ISSUE	BY	DATE	DESCRIPTION
4		09.03.21	ADDENDUM 1
		08.12.21	100% FOR BID - FOR CONTRACT
		08.06.21	100% CD SUBMISSION
		07.01.21	DCA SUBMISSION
		04.23.21	90% CD SUBMISSION

PROJECT TITLE
NEW CONSTRUCTION BRANDT BEHAVIORAL HEALTH TREATMENT CENTER & RESIDENCE
 100 - 102 COLLEGE FARM ROAD EAST, NORTH BRUNSWICK, NJ 08901
 DRAWING TITLE
ENLARGED RESIDENTIAL LAYOUT AND GRADING PLAN

L111

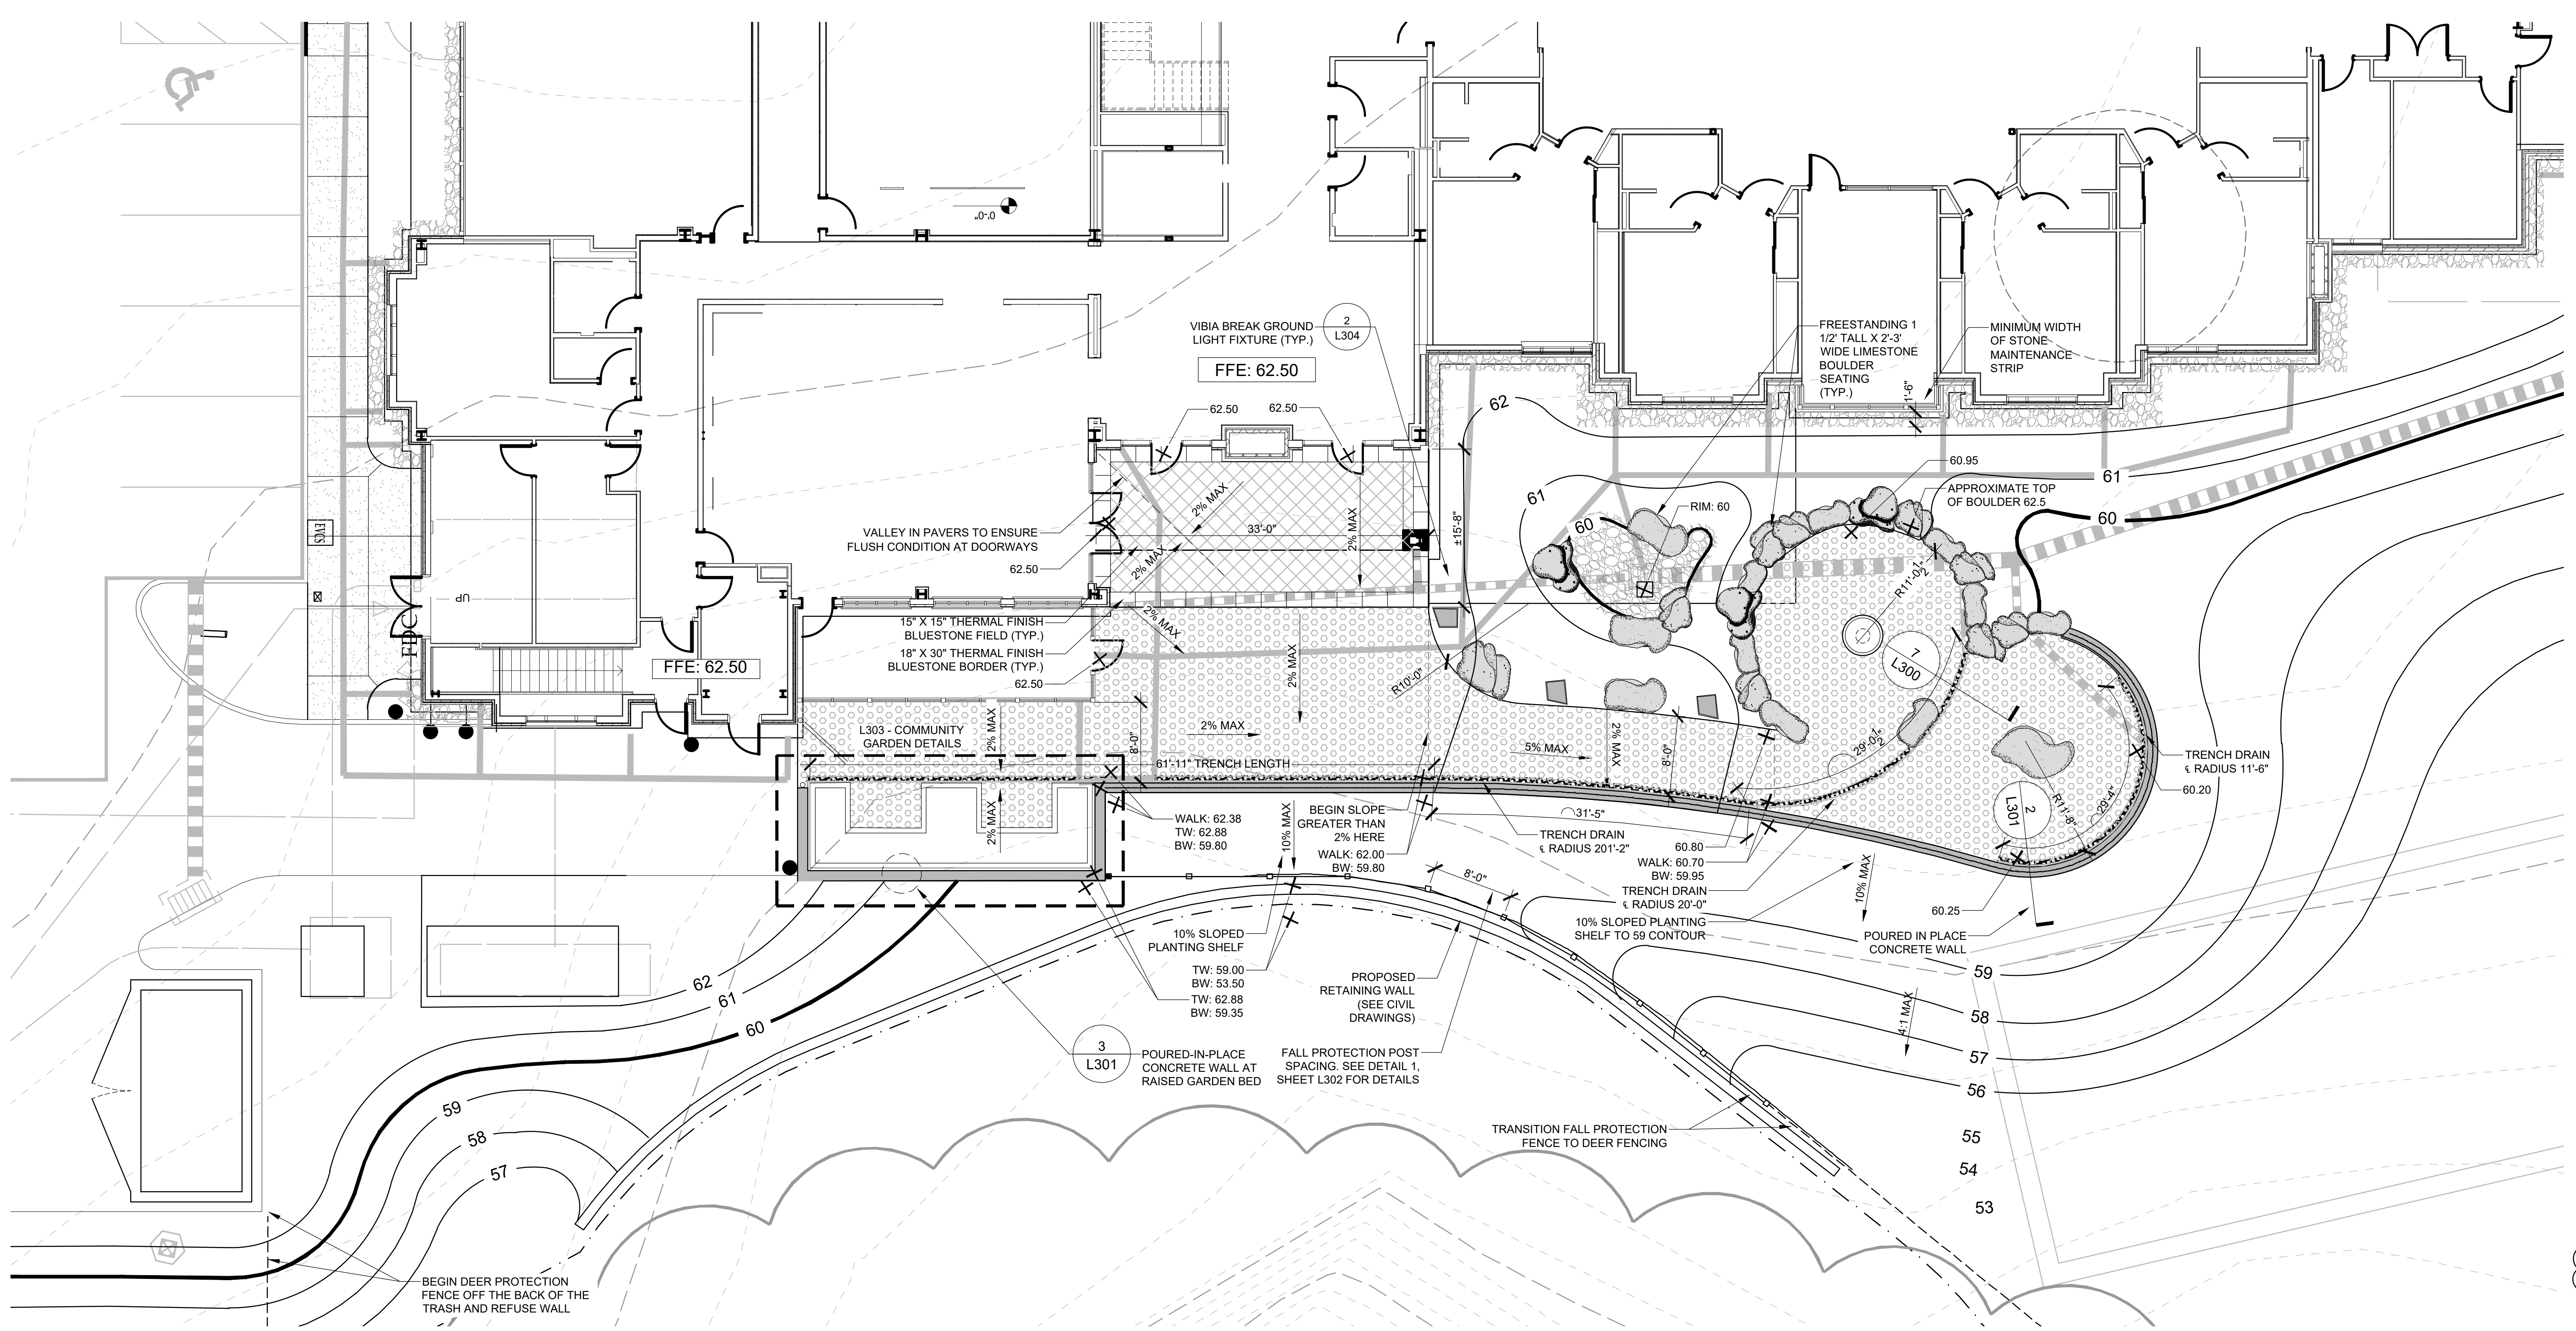
THIS SHEET HAS BEEN RE-ISSUED TO REFLECT THE REVISED UTILITY LINENWORK
